They Site Plan Review Committee (SPRC)
Staff Report for
1840 Wilson Blvd. – NSTA Site

NSTA Site (SP #382)
1840 Wilson Blvd. (1805 Clarendon Blvd.)
(RPC#s 17-011-057, -056)

DATE: April 15, 2024
TIME: 7:00 PM
PLACE: 2100 Clarendon Blvd. Room 216

Clarendon Blvd. Encroachments

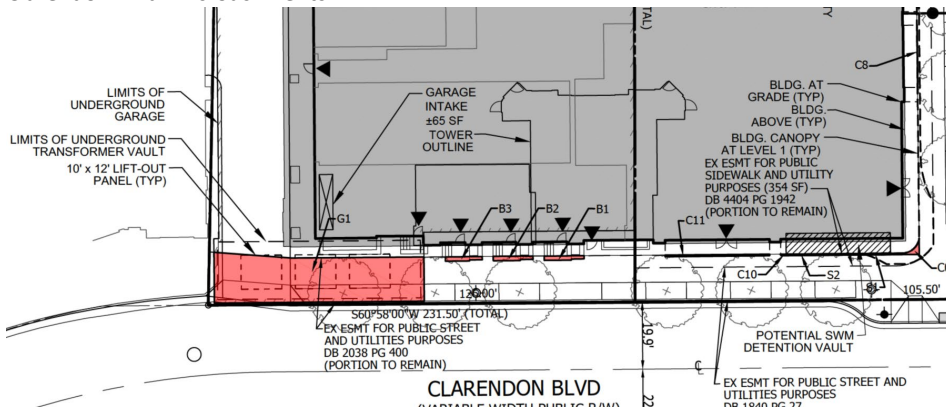
Site Design: The RCUDS identifies several design recommendations for this site including no curb cuts on Rhodes St, pedestrian friendly treatment on the ground floor, parking and loading accessed from the alley, and continued 12-foot minimum sidewalk along Rhodes Street and 16-foot minimum wide sidewalk along Wilson Boulevard and Clarendon Boulevard. Most of these design recommendations are being met in the applicant’s proposal. However, the residential stoops on Clarendon Blvd encroach into the recommended 8-foot clear zone creating a non-continuous clear zone with a pinch point

of 6.5-foot clear sidewalk. The encroachments can be seen marked by the narrow red lines in the image below. Staff has been working with the applicant to explore solutions to maintain the stoops while also maintaining an 8-foot clear-width sidewalk. The applicant has looked at revising the massing of the stoops and alternative planting area size areas to eliminate the encroachment of the stoops. Staff continues to evaluate if the solutions presented are appropriate at this location.

Building Height – Site Section Rhodes Street

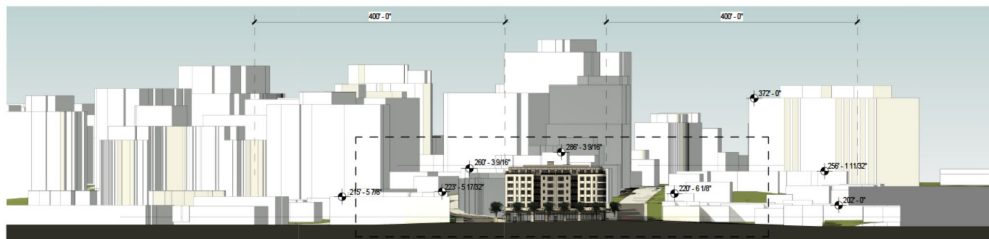
Building Height and Massing: The applicant is proposing a 7-story building, with building step backs at the 6-story level along all sides of the building and step backs at the second story along the north and south sides of the building. The RCUDS recommends a 5-story building, 55-feet tall, at this location. The RCUDS recommends flexibility for building heights to “accommodate affordable housing, community facilities, special design considerations, and/or new streets.” Moreover, the existing approved, but unconstructed office approval is permitted up to 6-stories.

CORNER OF WILSON AND RHODES

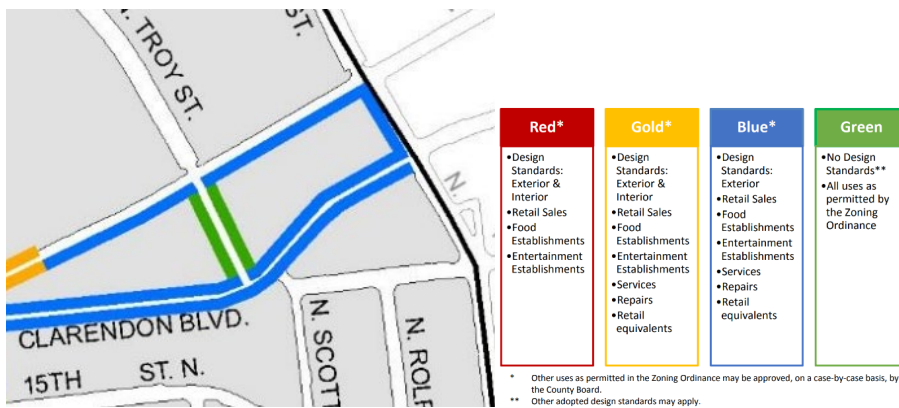
Architecture: The corners of the building at Clarendon and Wilson Boulevards and Rhodes Street are designated for special architectural treatment. The applicant is proposing a rounded corner at Wilson Boulevard and Rhodes Street to pay homage to the rounded façade on the existing Rhodeside Grill building. Staff continues to analyze the architecture and work with the applicant throughout the public review process.
